CMD Final Industry Stakeholder Comment Matrix

Name: Mark Thompson Organization: TransCanada Energy Ltd. (TCE)

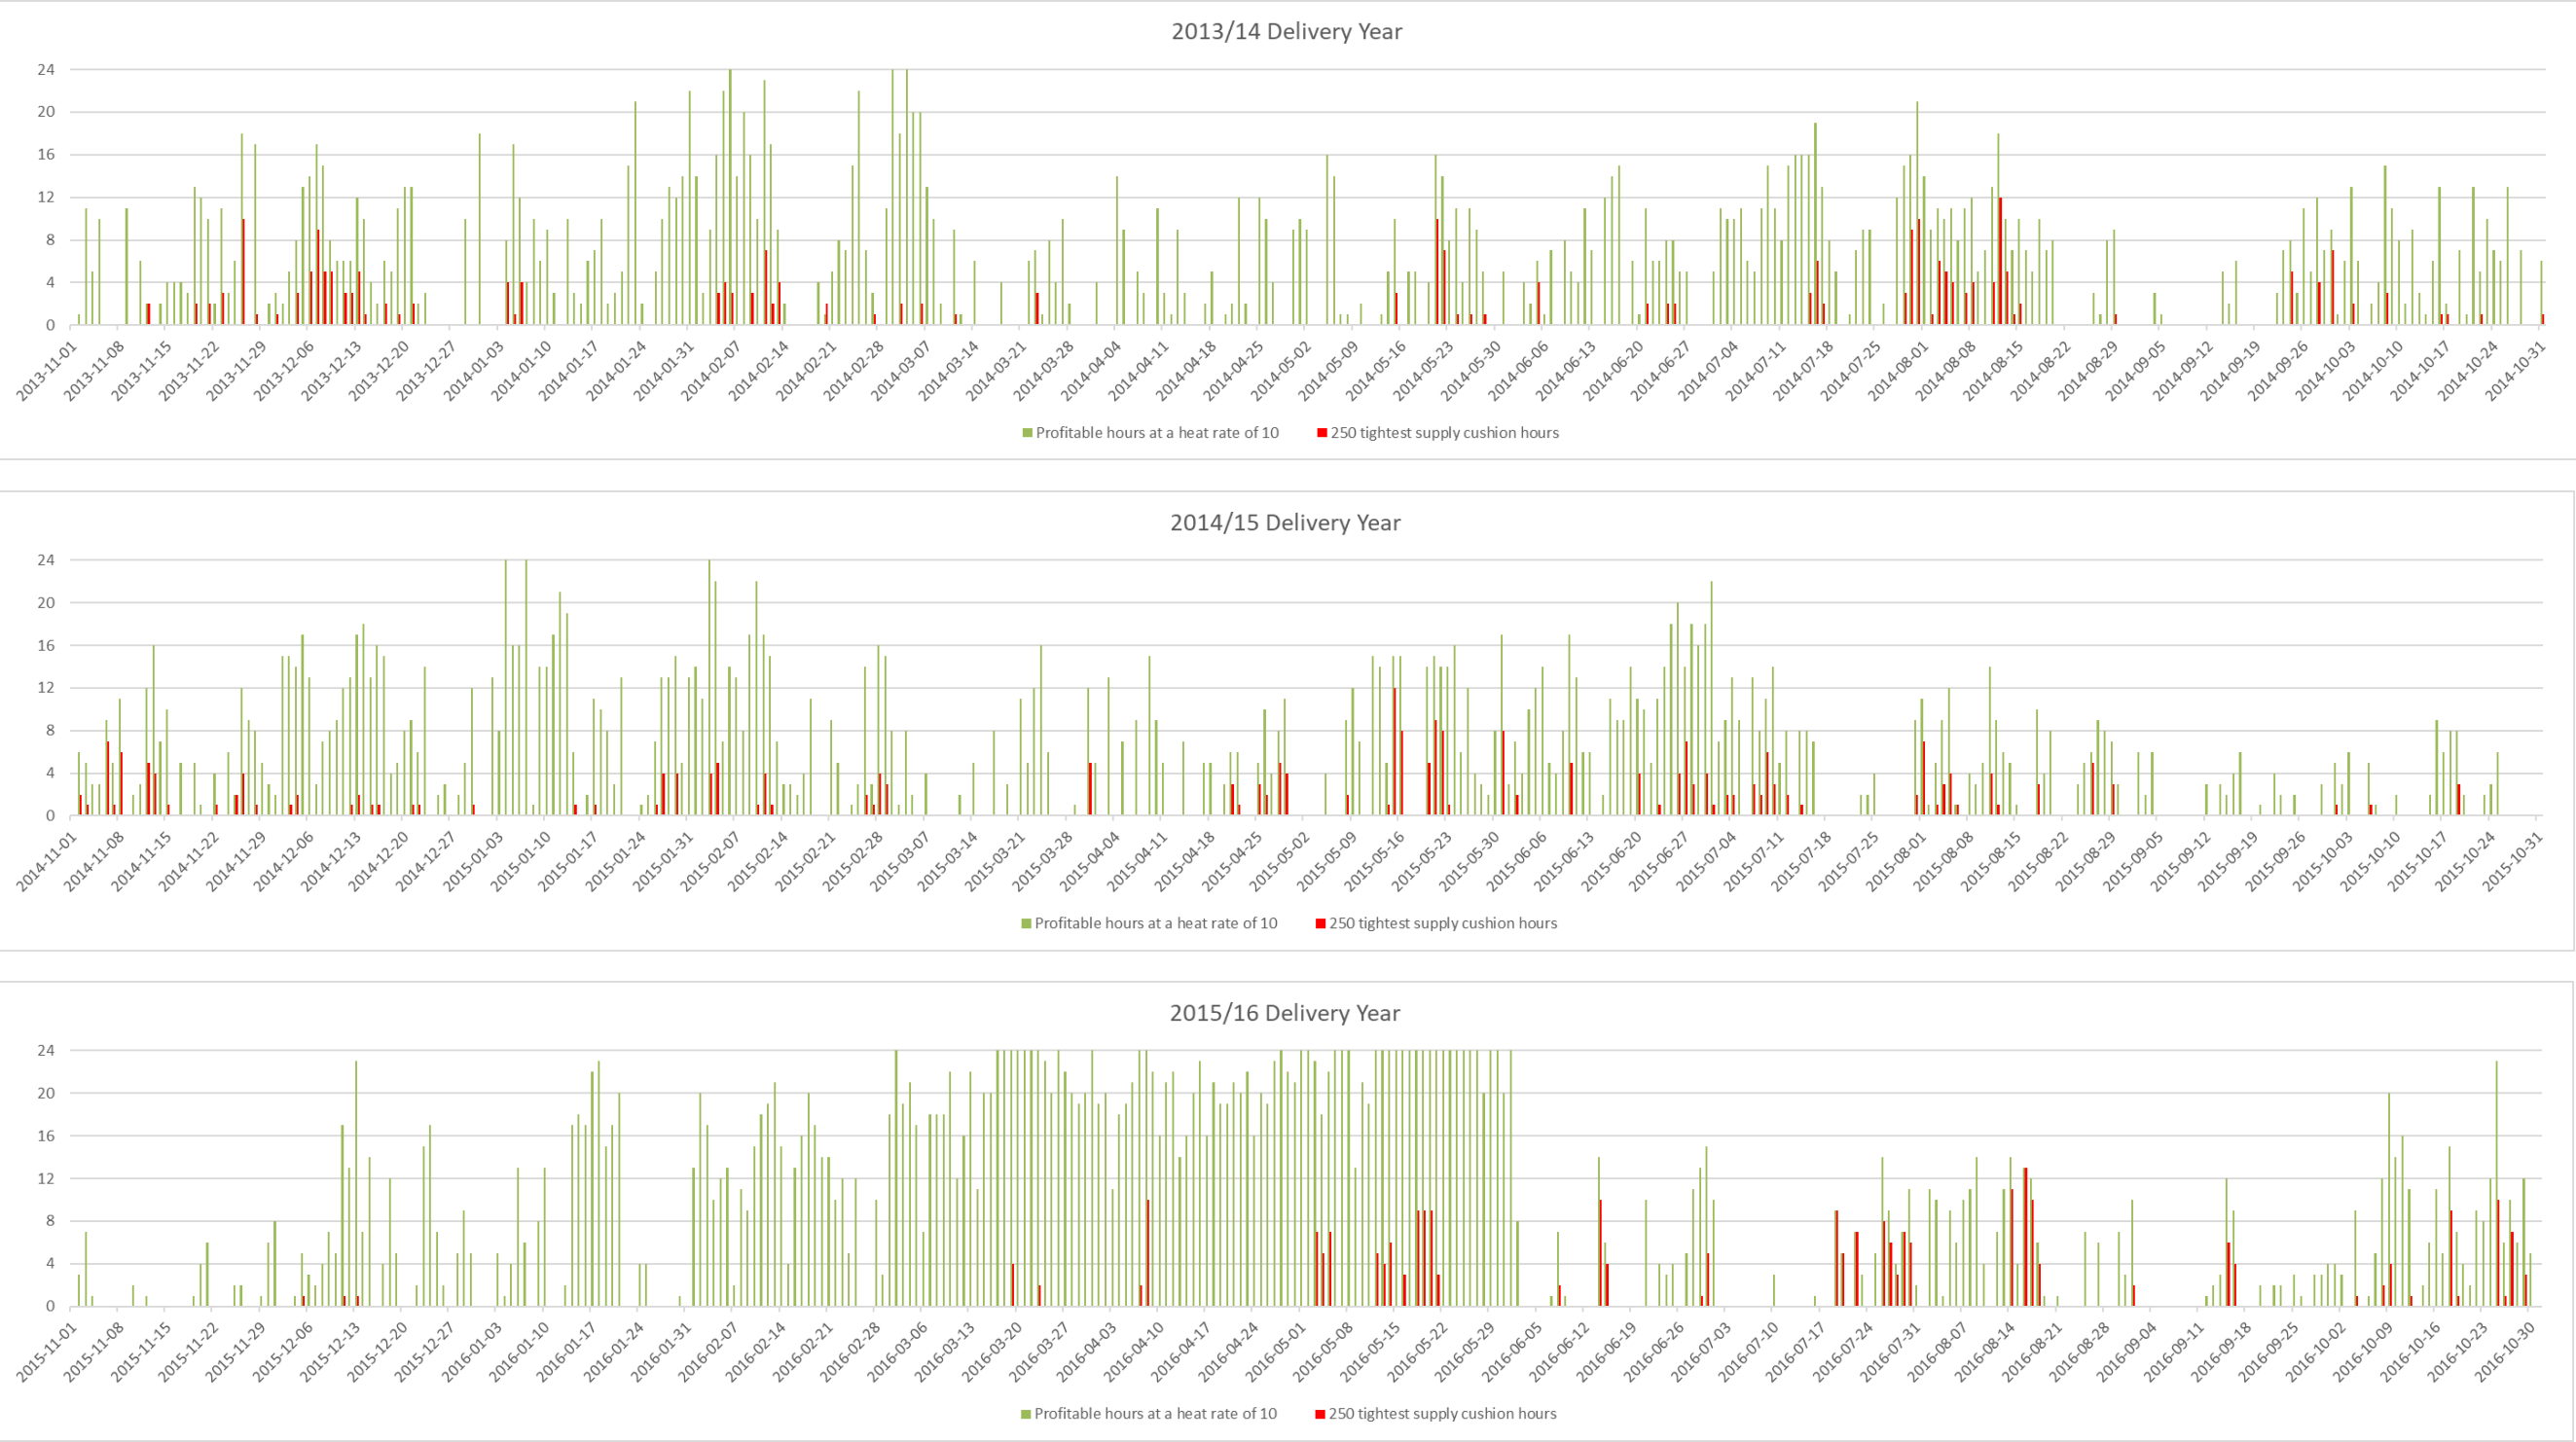
TCE recommends the AESO use 1,000 hours per year for the calculation of UCAP. While the use of 250 hours per year is better than 100 hours, TCE has the following concerns:

- The use of 250 hours per year represents only 2.9% of the annual hours, and will account for all capacity market revenues and a large proportion of energy market revenues. Historically, under the energy-only framework, approximately 1,140 hours per year returned 90% of the annual profits for a peaking plant (evaluated at a 10 heat rate). Accordingly, the current proposal imposes a significant increase in risk compared to the energy-only framework, contrary to a key goal of the market transition. In its original recommendation paper, the AESO stated that the capacity market was required to increase revenue certainty and reduce risks for investors because the energy revenues were expected to be more volatile and more concentrated due to a significant increase in intermittent renewable generation. The currently proposed UCAP and penalty framework do not accomplish this goal. Increasing the number of hours in the UCAP calculation to 1,000 is more consistent with historical levels of risk from a delivery perspective. More hours will average out risks of random scarcity events over the year. Using 1,000 hours will create a UCAP system that will be more representative of the capacity product and more stable from year to year, which will reduce risk to generation investments. In the following charts each green bar indicates the number of profitable hours for the day over the course of one year. Each red bar indicates the number of hours for the day that were among the 250 tightest supply cushion hours for the year and thus represents the hours that provide value under the proposed framework. As shown in the charts, the number of hours that provide value under the proposed framework is significantly reduced relative to the energy-only framework.

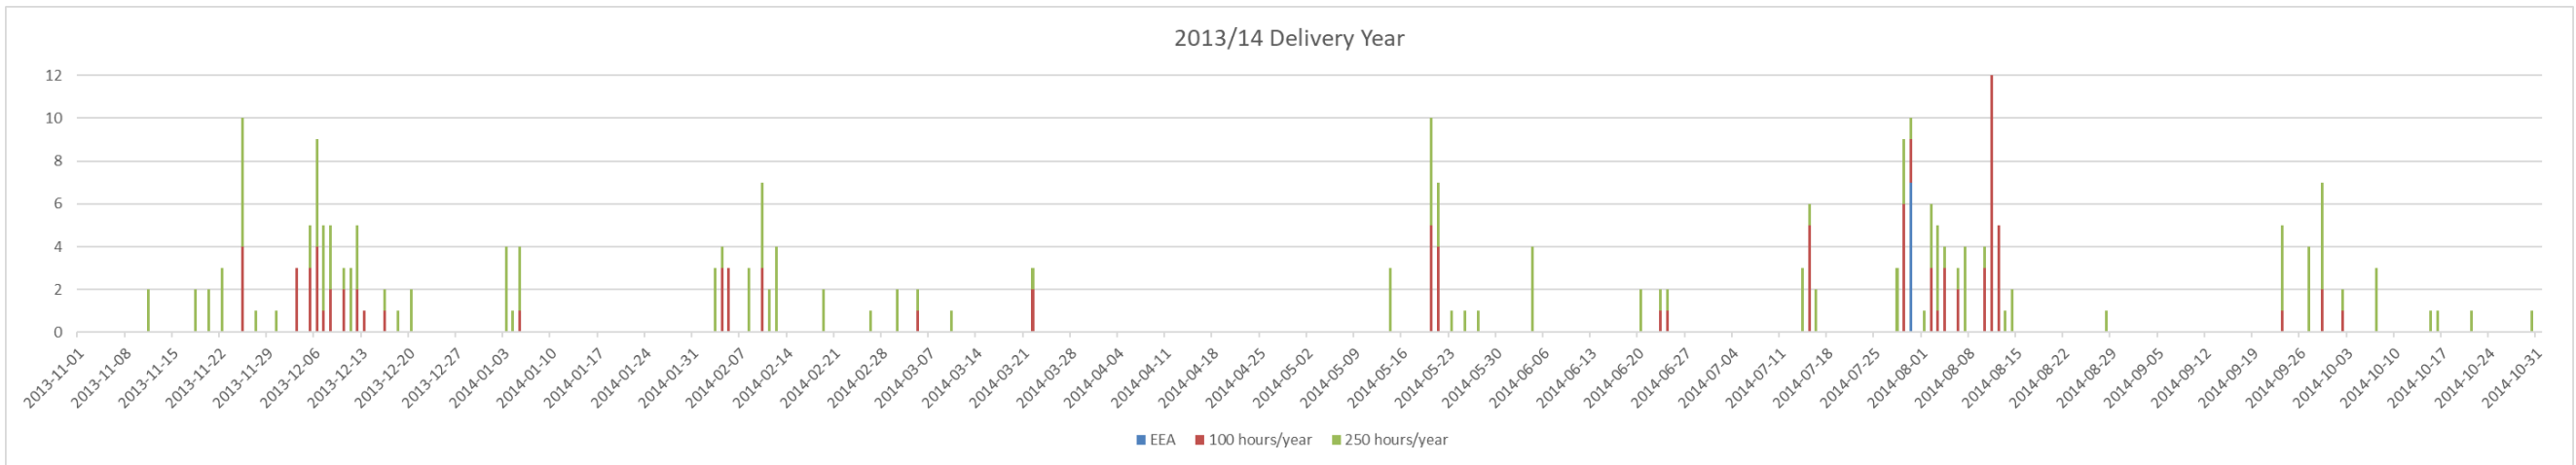
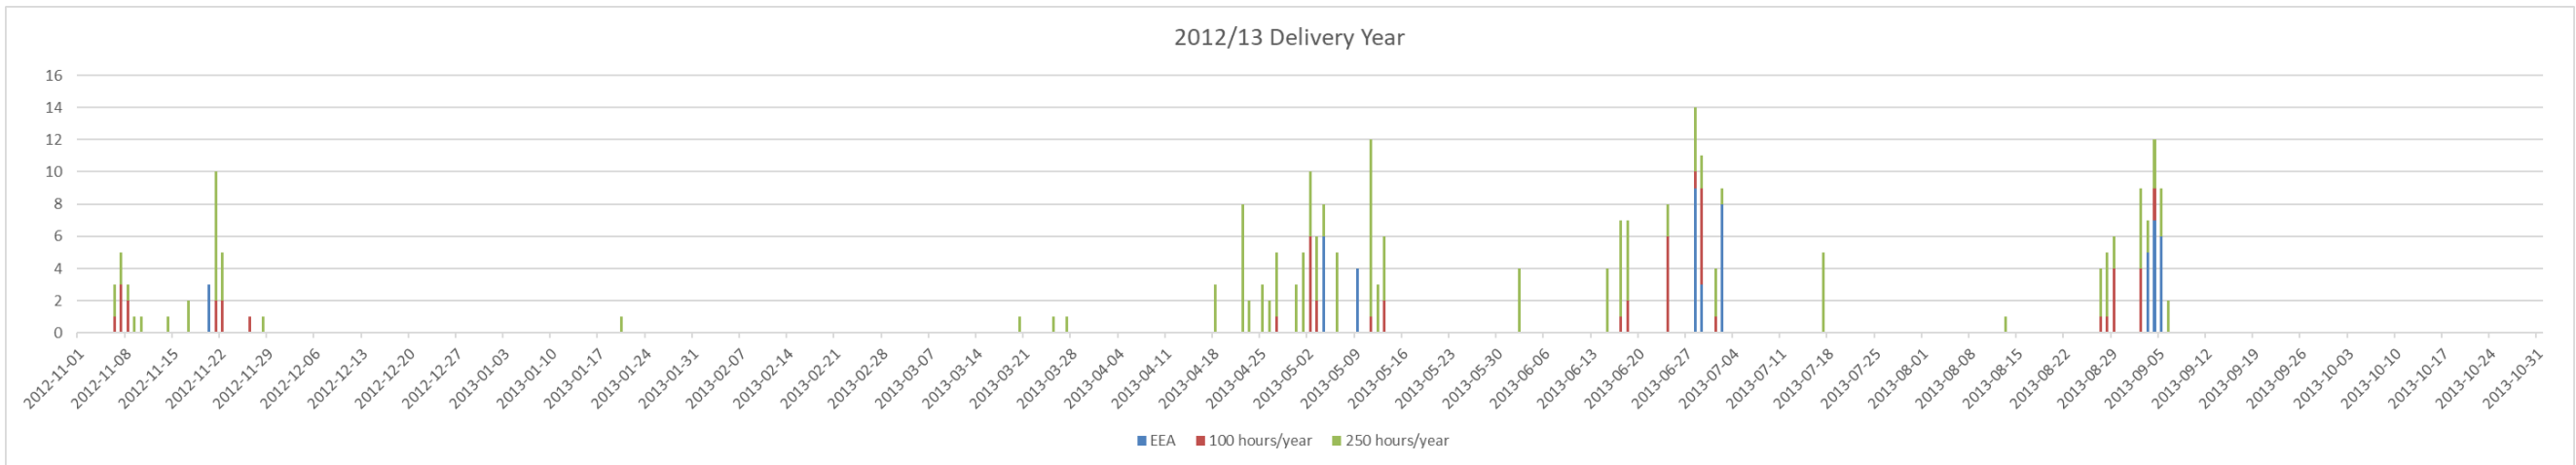
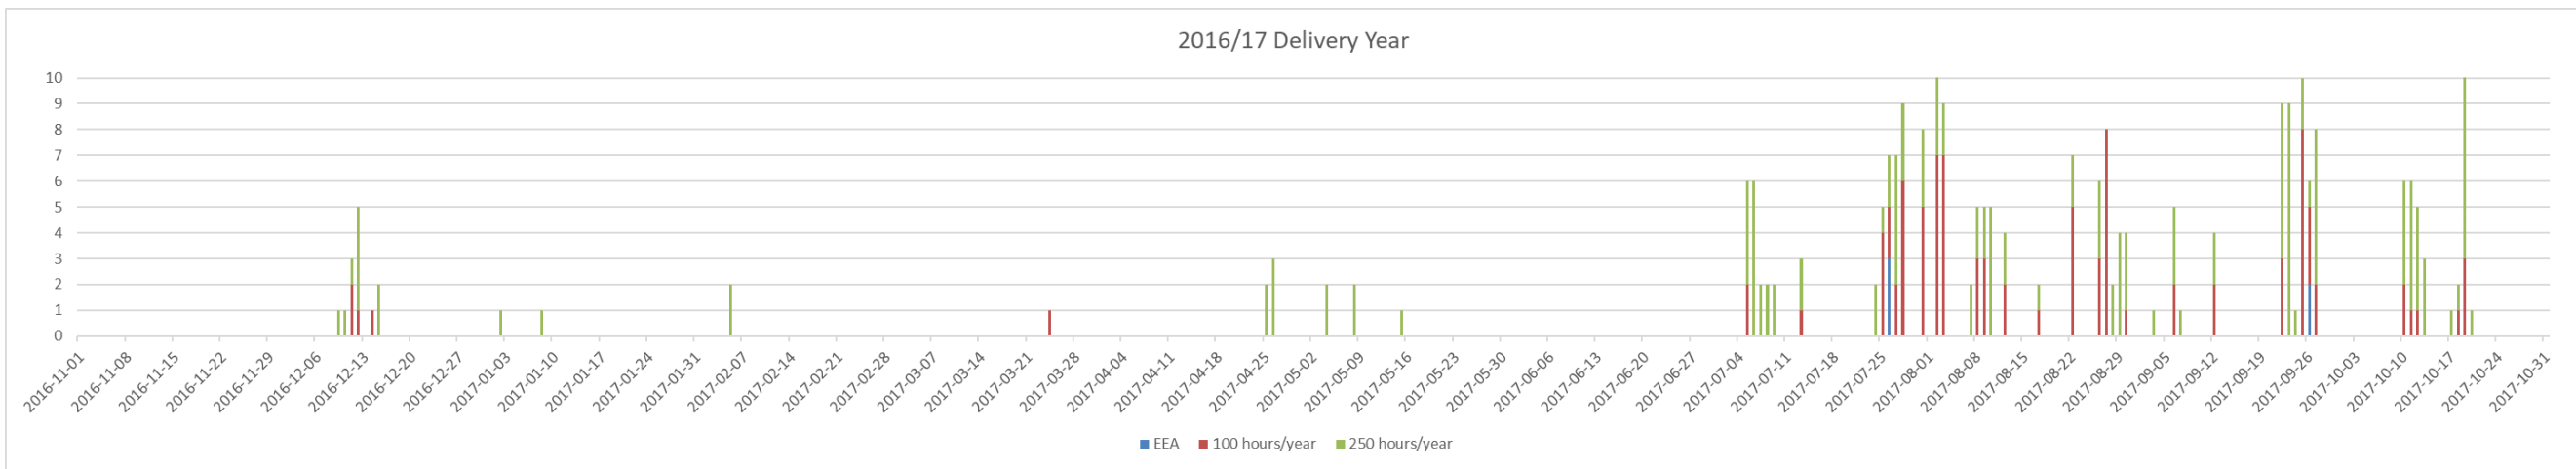
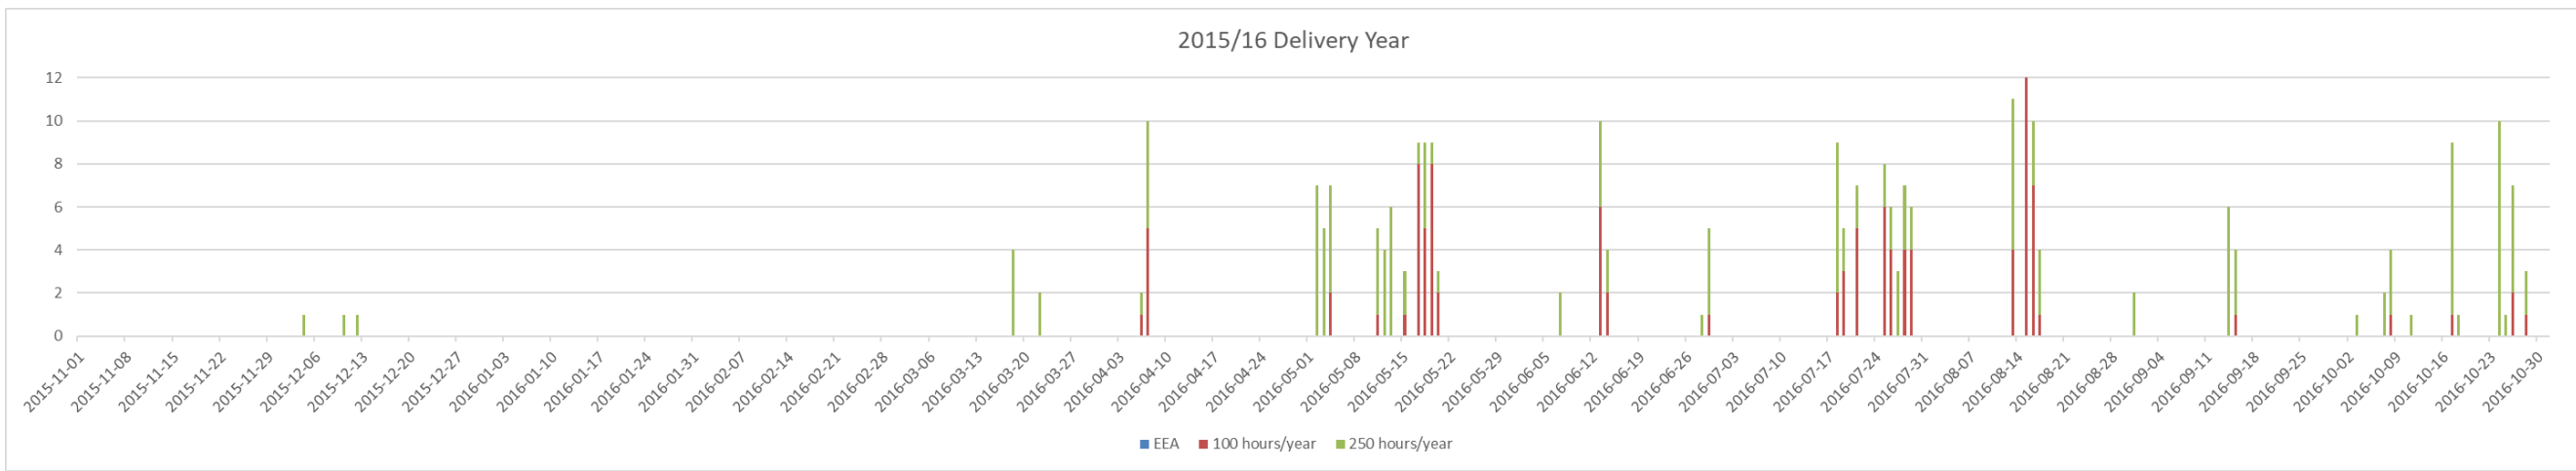
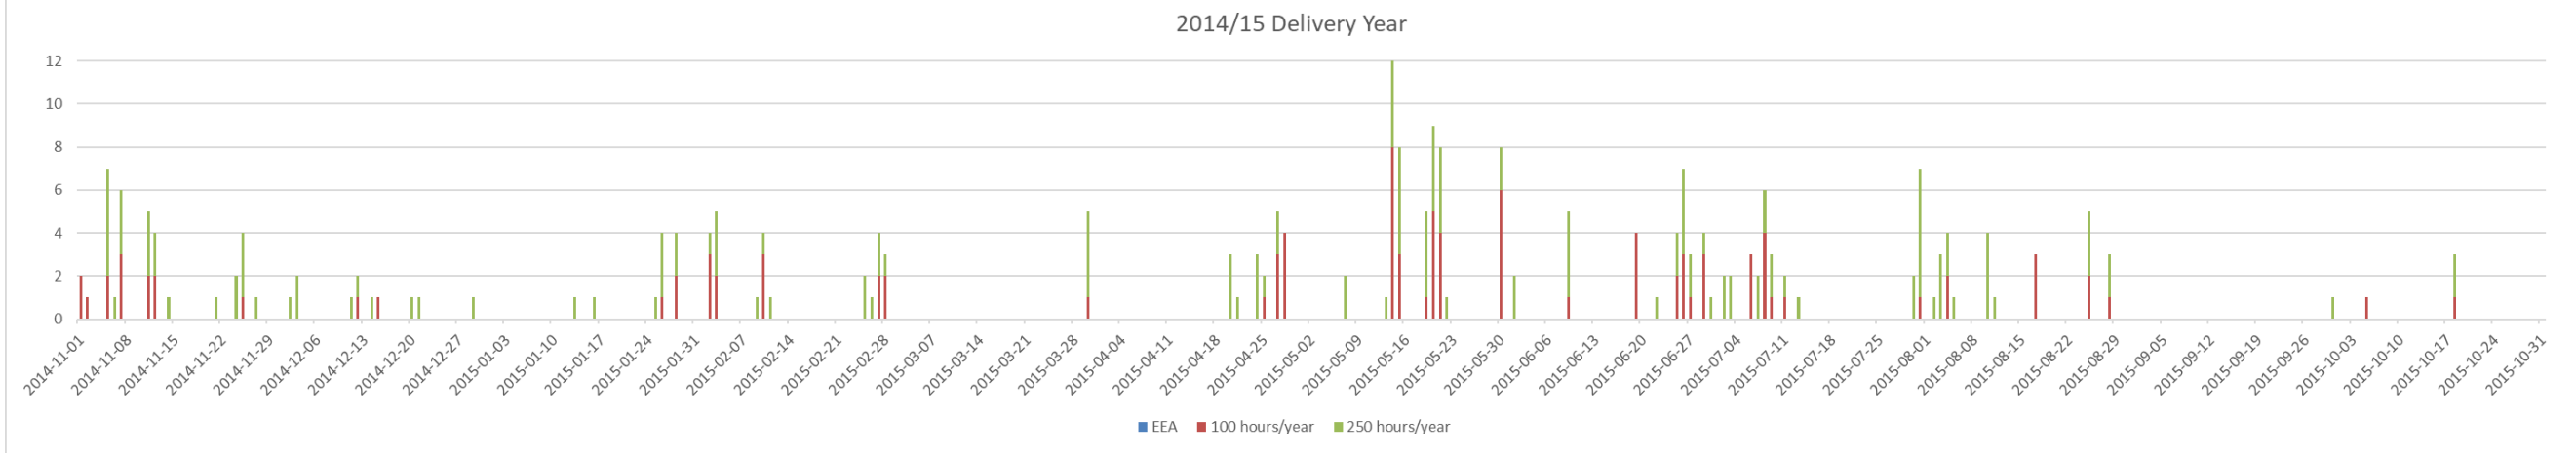
- The use of 250 hours per year does not materially diversify delivery risk, relative to the use of 100 hours per year, as the hours cluster and are typically contained within a small number of events. Increasing number of hours per year in the UCAP calculation to 1,000 increases the number of days and number of weeks measured. Using historical data over a five-year period, the tightest 1,000 hours per year would include at least one data point in almost 30 individual weeks and over 150 different days. This allows for a true diversification of risk in a way that 250 hours does not allow. The graphs below show the days covered by the 100 tightest hours in red and the incremental hours that would be added by moving to 250 hours in green. Where green hours are added on the same days that already contained red or blue, the additional hours have not diversified generator risk, especially outage risk.
